PROJECT NAME: LUNENBURG	PLOT DATE: 8/24/2015
PROJECT NUMBER: NH CULV(27)	DRAWN BY: W. GORDON
FILE NAME: \\b294\cos\z11b294frm.dgn	CHECKED BY: P. SHEDD
PROJECT LEADER: J. BYATT	SHEET 21 OF 74
DESIGNED BY: M. HALEY	
TYPICAL DETOUR SECTION SHEET

PROJECT NAME: LUNENBURG	PLOT DATE: 8/24/2015
PROJECT NUMBER: NH CULV(27)	DRAWN BY: M. HALEY
FILE NAME: 11b294/cos/z11b294bdr tcopl.dgn	CHECKED BY: P. SHEDD
PROJECT LEADER: J. BYATT	SHEET 22 OF 74
DESIGNED BY: M. HALEY	
PHASE I TRAFFIC CONTROL SHEET I

PROJECT NAME: LUNENBURG	PLOT DATE: 8/24/2015
PROJECT NUMBER: NH CULV(27)	DRAWN BY: M. HALEY
FILE NAME: Iib294/cos/zlib294bdr+oppl.dgn	CHECKED BY: P. SHEDD
PROJECT LEADER: J. BYATT	SHEET 23 OF 74
DESIGNED BY: M. HALEY	PHASE I TRAFFIC CONTROL SHEET 2

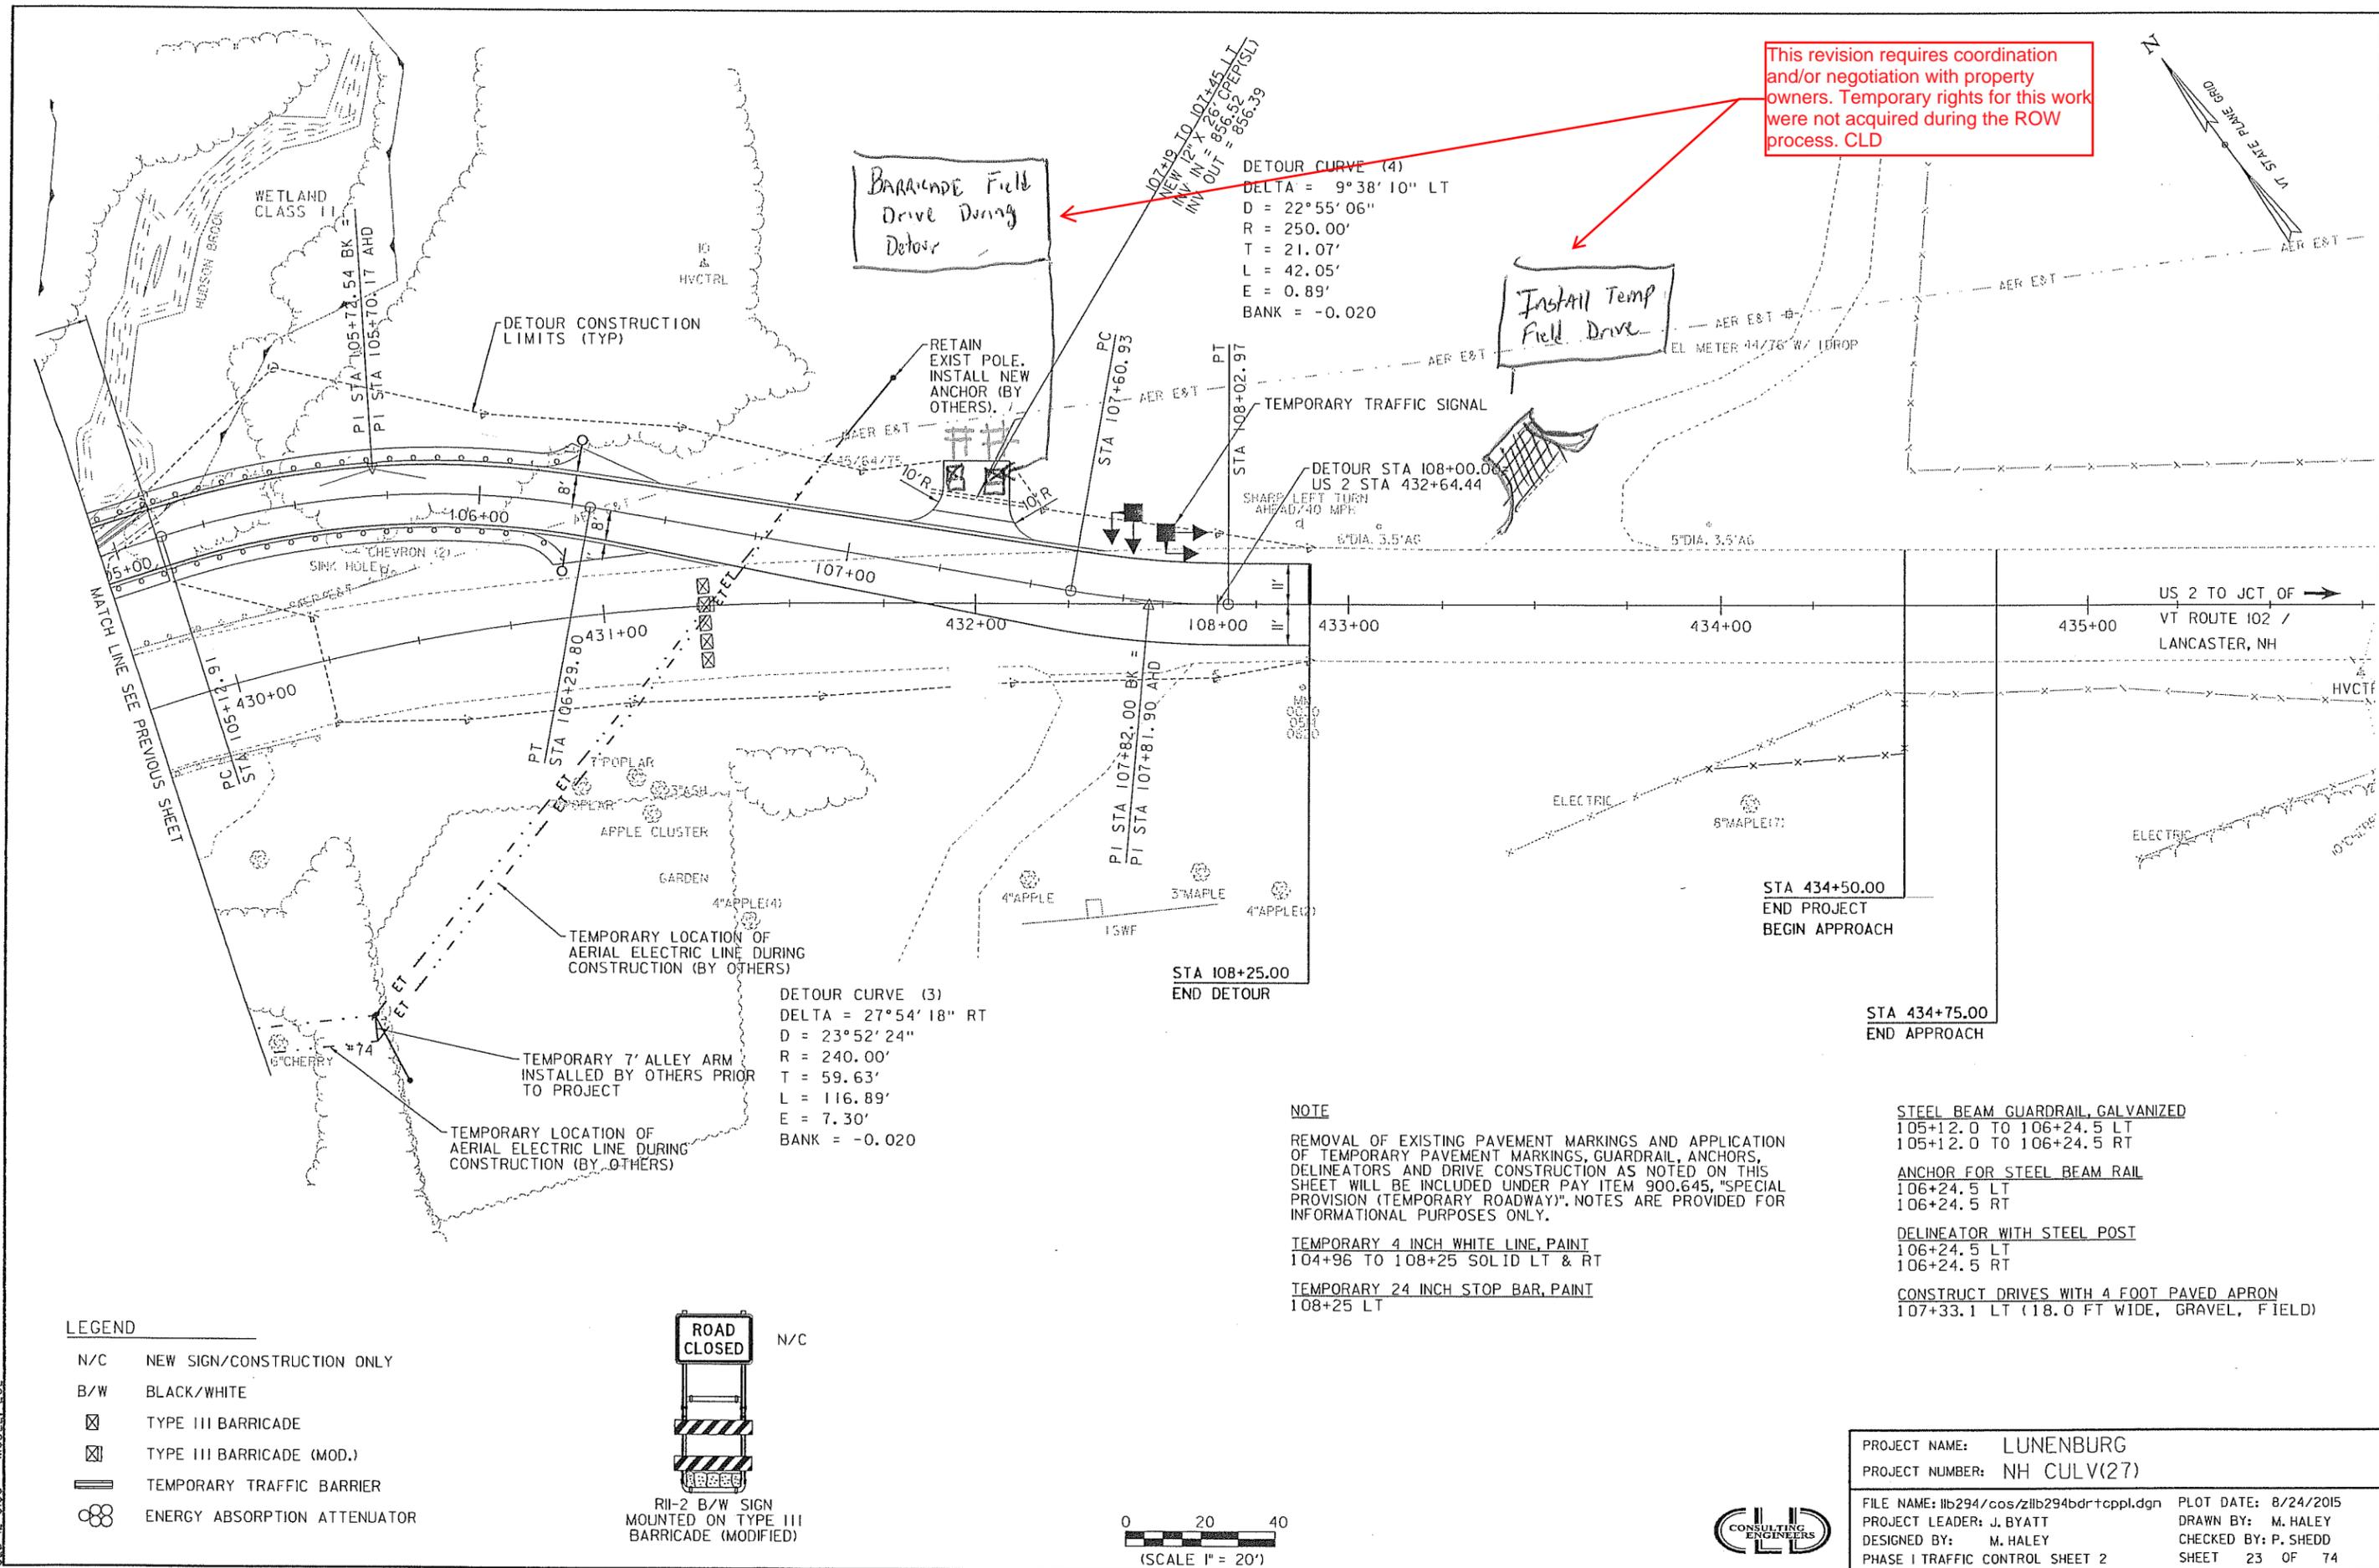
This revision requires coordination and/or negotiation with property owners. Temporary rights for this work were not acquired during the ROW process. CLD

BARRIENDE Field Drive During Detour

Install Temp Field Drive

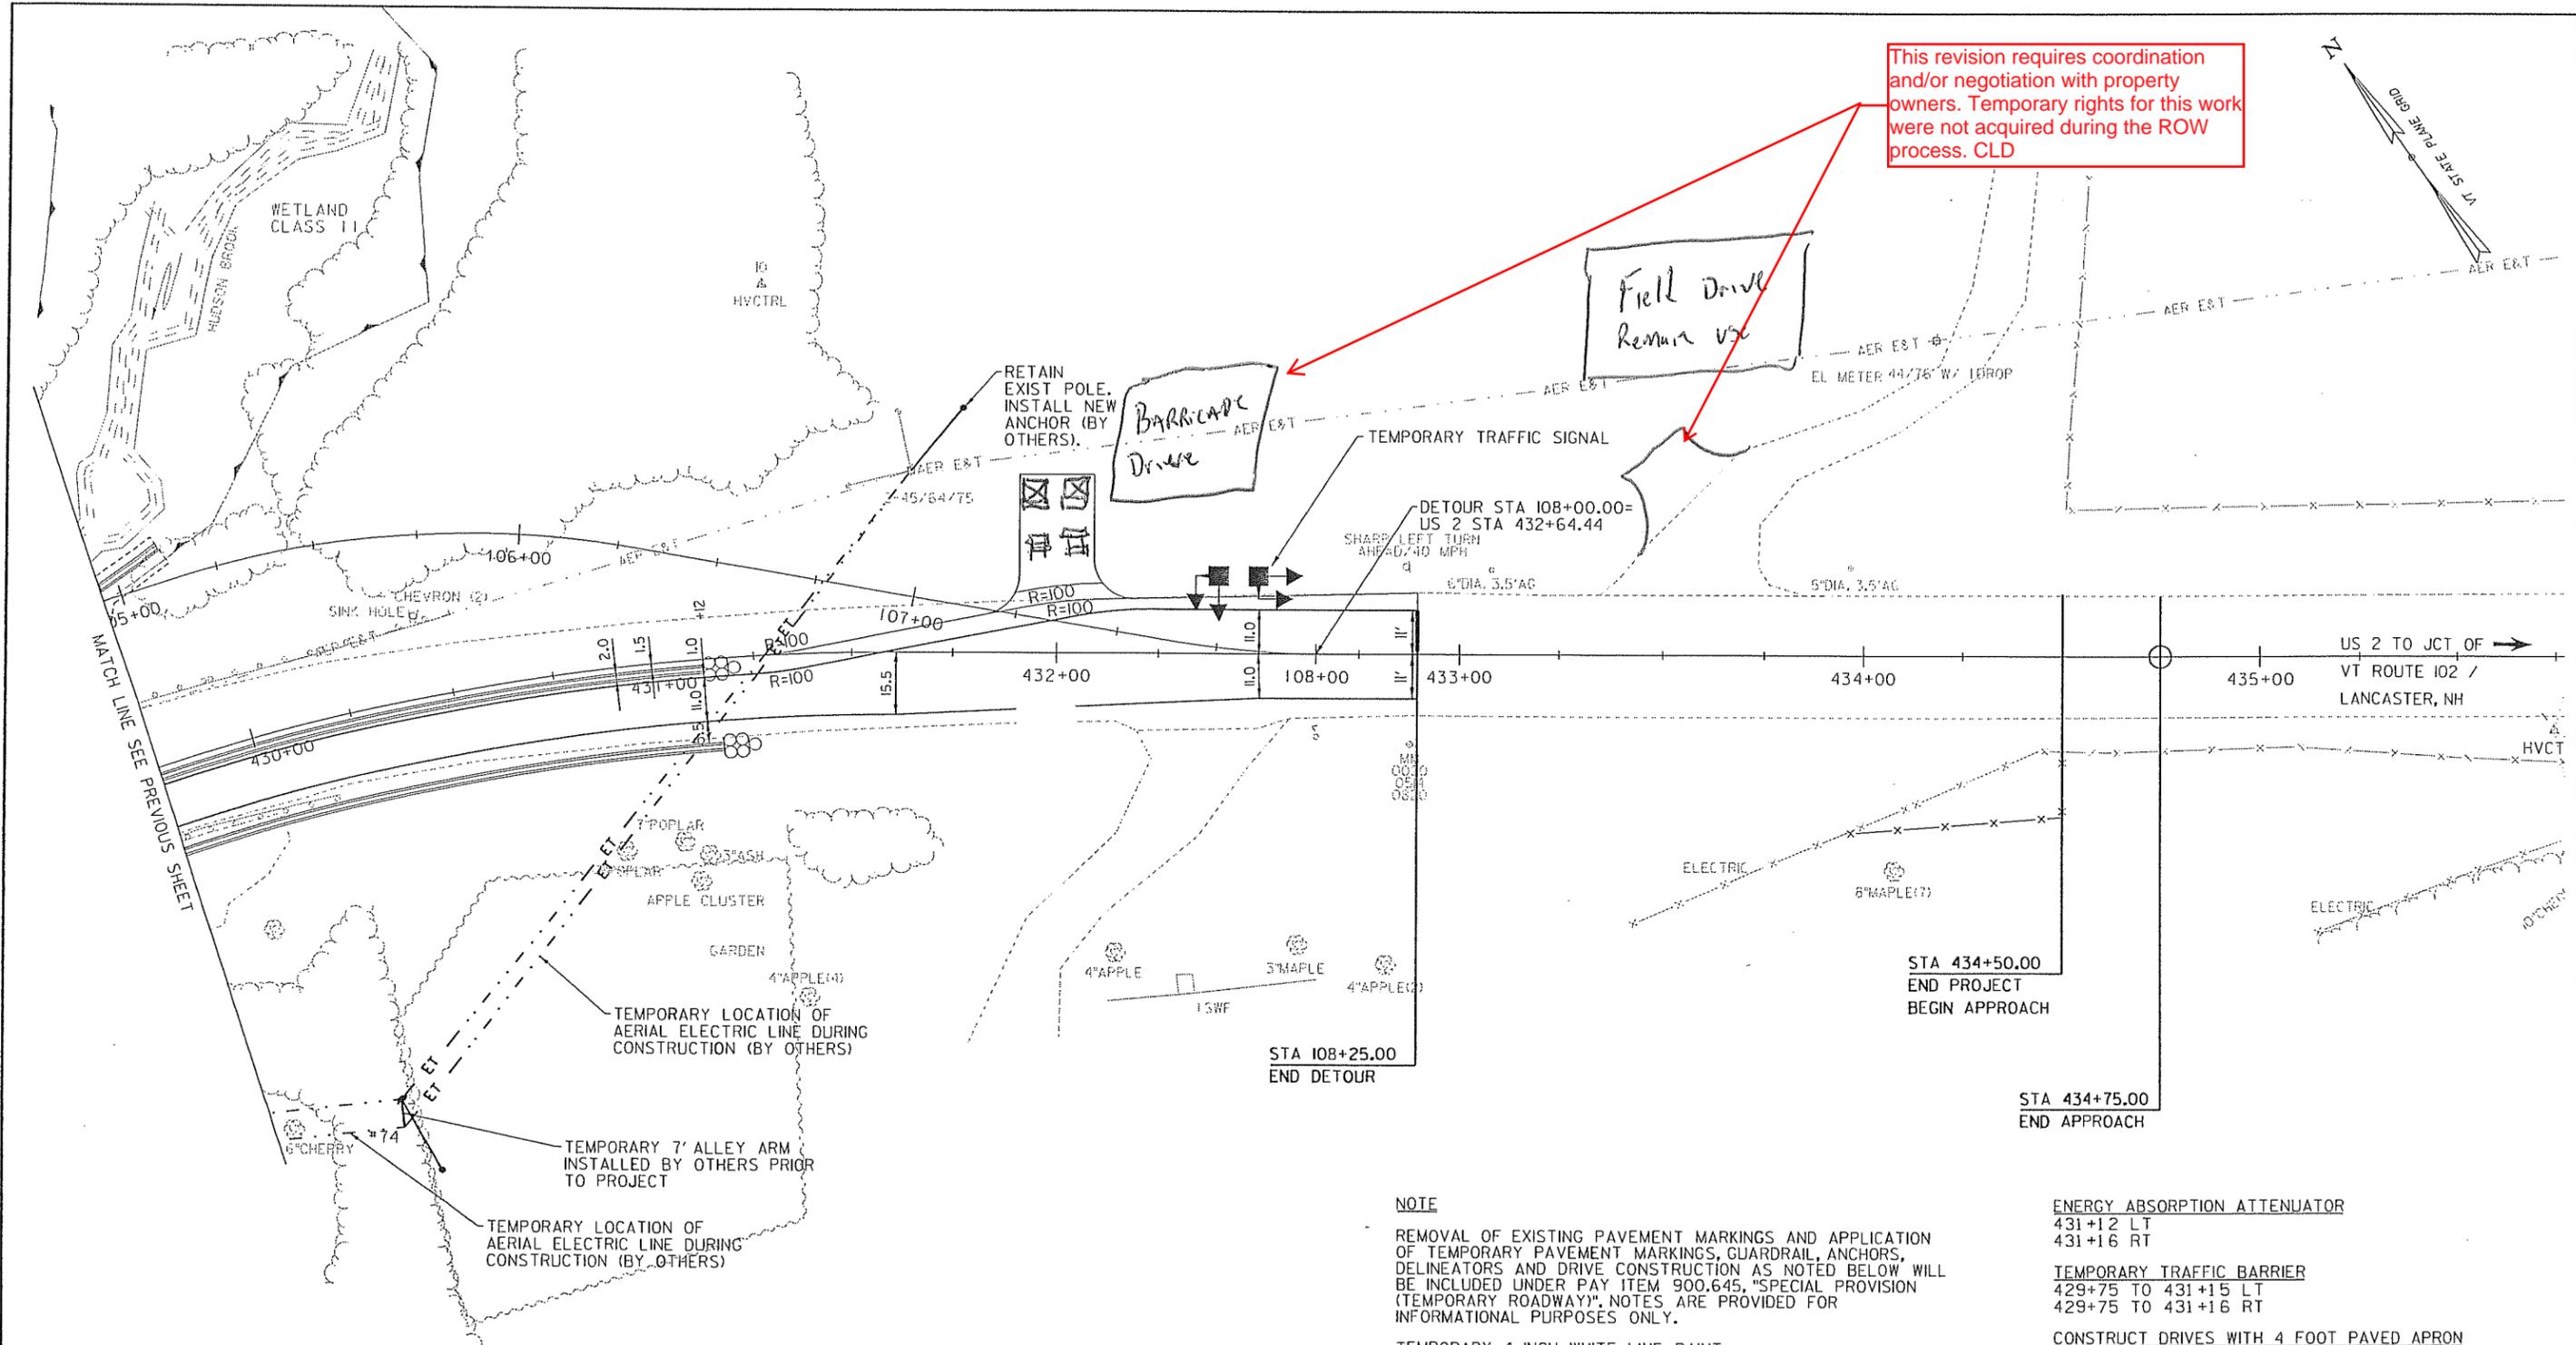
This revision requires coordination and/or negotiation with property owners. Temporary rights for this work were not acquired during the ROW process. CLD

PROJECT NAME:	LUNENBURG	PLOT DATE:	8/24/2015
PROJECT NUMBER:	NH CULV(27)	DRAWN BY:	S. GOODWIN
FILE NAME:	11b294/cos/211b294tr.f.dgn	DESIGNED BY:	R. LYFORD
		CHECKED BY:	P. KONIECZKA
		PHASE I TEMPORARY TRAFFIC SIGNAL SHEET	SHEET 28 OF 74

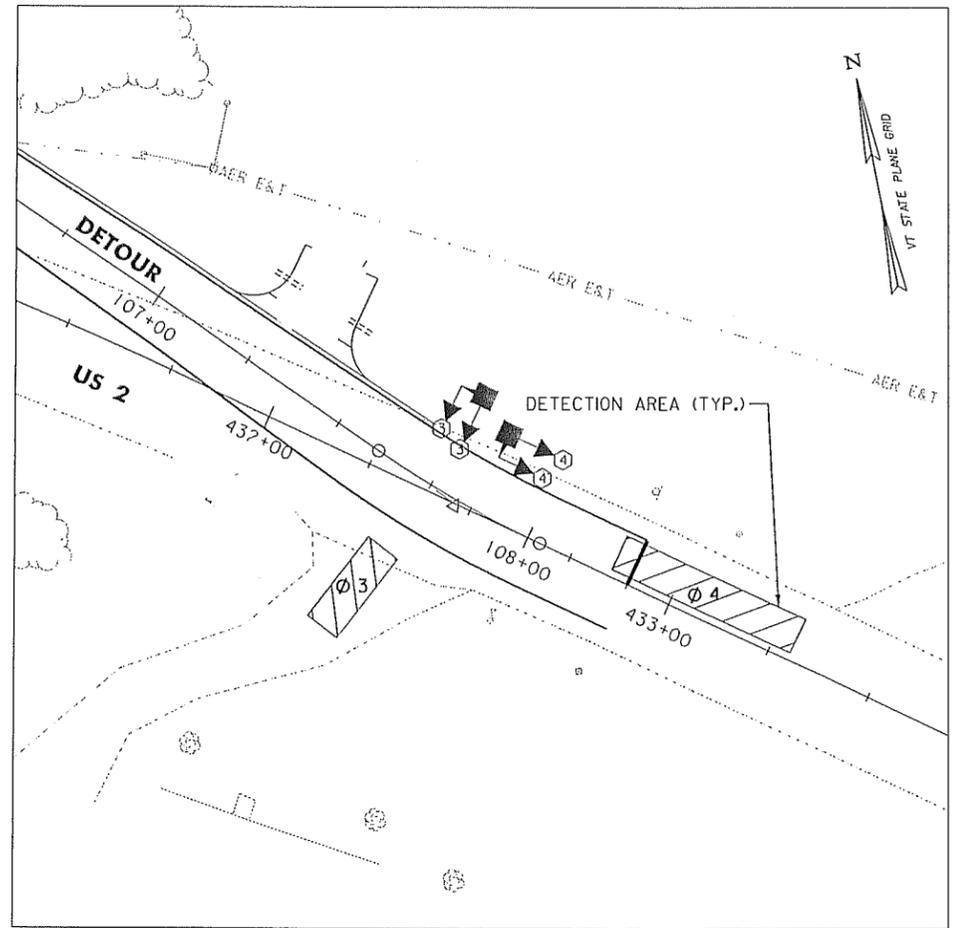
Although the driveway on the north side of US 2 is proposed to be relocated, this phase is needed for the driveway on the south side of US 2 so vehicles can safely exit the driveway due to limited sight distance to the west. Recommend this phase not be removed. CLD

FILE NAME: l1b294/cos/z11b294trf.dgn PLOT DATE: 8/19/2015
PROJECT LEADER: J. BYATT DRAWN BY: S. GOODWIN
DESIGNED BY: R. LYFORD CHECKED BY: P. KONECZKA
PHASE 2 TEMPORARY TRAFFIC SIGNAL SHEET SHEET 29 OF 74

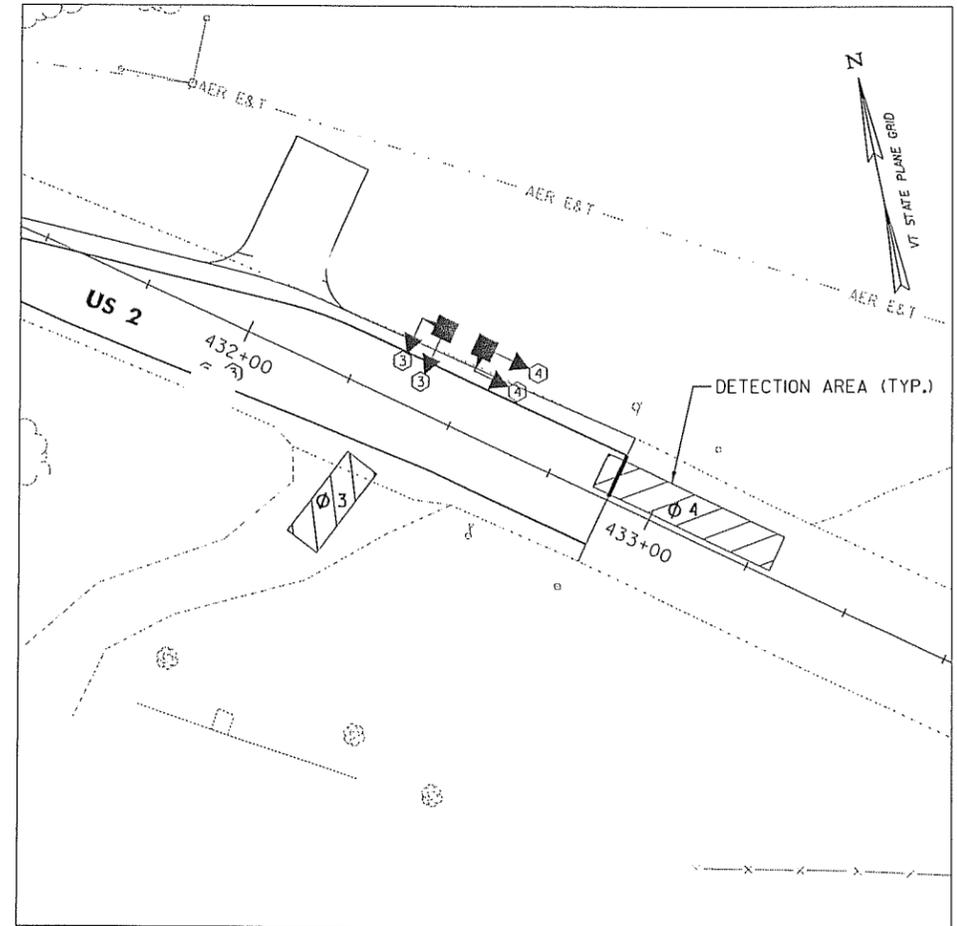
Although the driveway on the north side of US 2 is proposed to be relocated, this phase is needed for the driveway on the south side of US 2 so vehicles can safely exit the driveway due to limited sight distance to the west. Recommend this phase not be removed. CLD
